Application reference: EPR/DP3492ZX/V003
Applicant: YORKSHIRE WATER SERVICES LIMITED

Facility: Sandall Waste Water Treatment Works, Wheatley Hall Road, Doncaster,

Deadline 05/02/2024 Submitted 05/02/2024

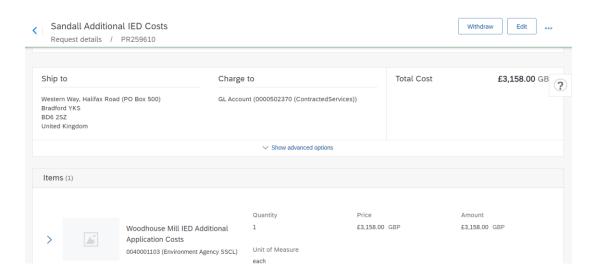
response to Q2 for further on this matter.
Application fee for the physical treatment of non-hazardous waste relating to temporary storage of cake	£3,965	There will be no physical treatment of non hazardous waste.
- Application fee for a - Minor variation fee to remove activities R13 and R2 relating to the sludge conditioning activities. (see section 3.4.2 of guidance https://www.gov.uk/government/publications/environmental-permitting-charges-guidance/environmental-permitting-charges-guidance)		R13 is still applicable in regards storing of waste prior to digestion in addition to storage of waste post digestion. It is also applicable with regards gas storage. This code is to remain in the permit please. Fee raised for the removal of
	£2,379	R2, which is no longer required.

The payment is currently going through the approval's process. Please see the following screenshot as evidence that this payment has been raised.
